Availability of Complete Non-Current Bravo Sterndrives

Models Affected

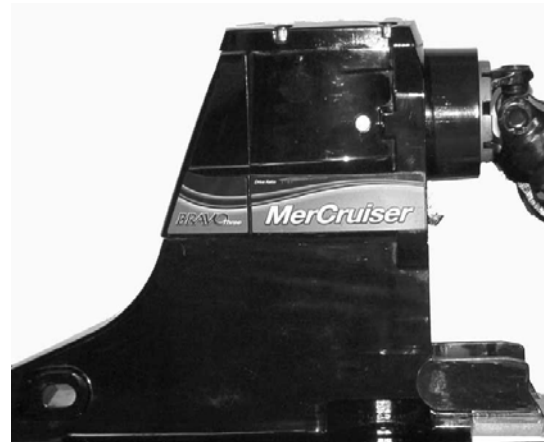
Mercury MerCruiser is recommending and encouraging the use of new style current production Bravo Plus sterndrives whenever possible. Non-current style Bravo sterndrives will no longer be available as complete units when existing inventories are exhausted. Check for availability of non-current style Bravo sterndrives.

There are two options available:

1. Order a new style Bravo Plus complete sterndrive to replace the non-current sterndrive (desirable for single engine applications).

- Order a complete drive shaft housing assembly, complete gear housing assembly, decal set and attaching hardware if needed. These can be assembled together to create a complete non-current style Bravo sterndrive (appropriate when replacing one sterndrive unit on a multiple engine boat).
